No. EL/3.1.35/2 (Brake Lever)

SPECIAL MAINTENANCE INSTRUCTION
No. RDSO/2014/EL/SMI/0280 (Rev. '0') Dated: 05.05.2014

Maintenance instructions to prevent crack/ breakage of TM mounting bogie nose in WAP7/WAG9 locomotives.

**Bogie Mounting
Nose**

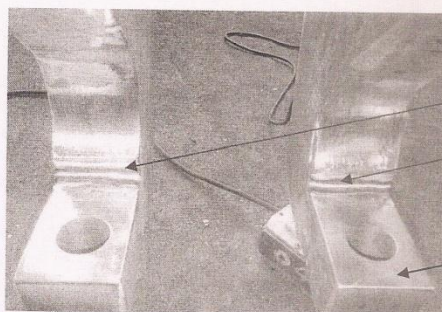
As per CLW drawing no. 1209-01-112-009 Alt '1', fillet radius of 8mm on the bottom surface of TM mounting bogie nose is specified and fillet radius on the upper face of the bogie nose lugs are shown but is not specified.

To assess the situation, different bogies were observed at ELS/LGD and it was found that CLW built bogie frame had fillet radius of 8mm on upper face of bogie mounting nose (even-though the radius is not specified in the machining drawing of the CLW) whereas bogies supplied by others vendors had not fillet radius.

The failure of bogie mounting nose in fatigue manner may be attributable to sharp edges at lug hole portion which had acted as notch for fatigue initiation. Development of crack and subsequent failure of bogie mounting nose is due to stress concentration at the lug portion due to sudden change of machining profile.

- One round in situ DPT should be conducted on bogie mounting nose in all bogies of WAP-7/ WAG-9 locomotives after removal of paint on the first opportunity.
- One round of making fillet radius of 8mm on upper face of bogie mounting nose should be carried out immediately by minimal cutting of upper face of bogie mounting nose manually using tungsten carbide buffer tool (16mm spherical). All tool marks should be polished using grinding wheel.
- A modified design of bogie mounting nose to reduce stress concentration at lug portion is as below:-

**Fillet Radius
should be 8 mm**

- DPT should be conducted on the bogie mounting nose after machining. Champhering of edges of bogie mounting nose should be done by using grinding wheel.
- As a precautionary measure safety sling should be provided as per RDSO SMI NO. 269 (Rev. '0') to prevent falling of Traction motor in case of failure of bogie mounting nose in WAP7/WAG9 locomotive.
- DPT should be conducted thereafter on bogie mounting nose during every MOH/IOH/POH schedule.
- The bogie frame should be procured with fillet radius 8mm (R-8) on upper face of the bogie mounting nose. For this purpose CLW/CRJ should revise its drawing no.1209-01-112-009 to shown fillet radius of 8mm (R-8) on upper surface of the bogie mounting nose. Modified bogie frame should be procured as per revised drawing and fitted.
